**106 97TH AVENUE N.E.
BOUNDARY - TOPOGRAPHIC SURVEY**
A PORTION OF THE NORTHEAST 1/4 OF SECTION 31, TOWNSHIP 25 NORTH, RANGE 5 EAST, W.M.,
CITY OF BELLEVUE, COUNTY OF KING, STATE OF WASHINGTON

Response to Comments Letter
Bruce Project - 106 97th Ave NE
Bellevue, Washington
PN: 8056000090 & 8056000085 three?
Job: Bruce.97thAveNE.RCL

This letter is provided to address comments from Mr. Reilly Pittman of the City of Bellevue regarding our geotechnical report for the subject site dated June 5, 2015. Our response and/or excerpts from the above referenced Geotechnical Engineering Report are provided in italics immediately following each code item.

BDR BELLEVUE IX LLC
SITE PLAN B
FOR
BDR BELLEVUE IX LLC
128 97TH AVENUE NE, CITY OF BELLEVUE KING COUNTY, WASHINGTON

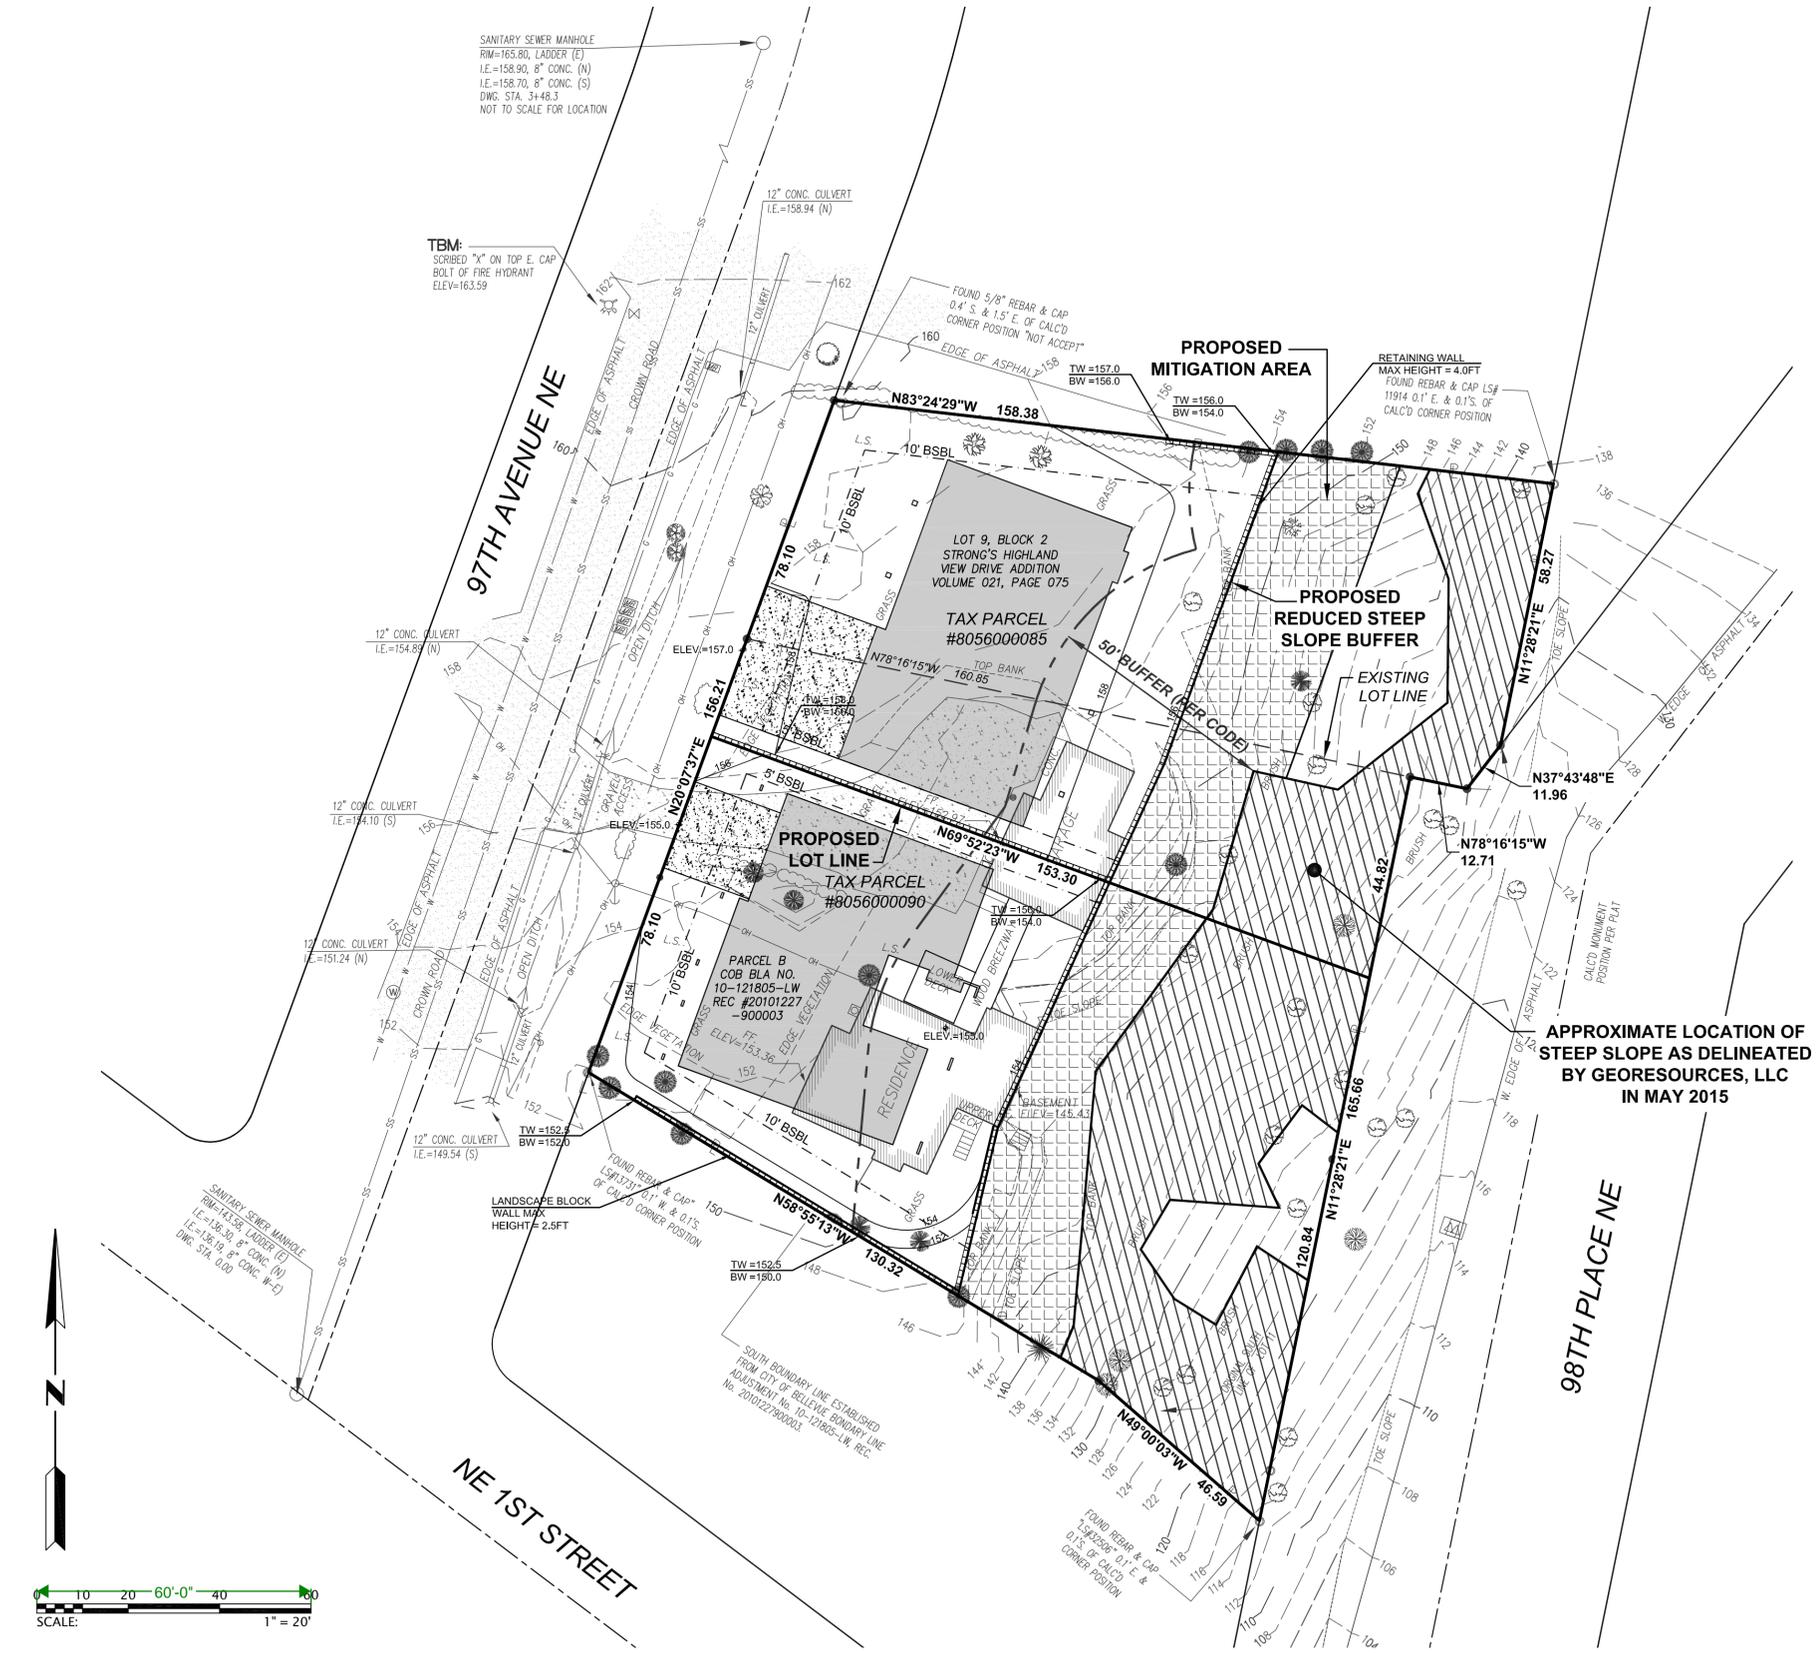
1. Site and Construction Plans. The report shall include a copy of the site plans for the proposal and a topographic survey;

A copy of the original proposed site plan and topographic survey was included in our Geotechnical Engineering Report as Figure 2a. An updated site plan showing the two new residential structures is attached to this letter. It should be noted that the new structures are situated outside of the hazard/critical area, and to a large extent outside of the buffer area. The existing residence and garage are highlighted in yellow.
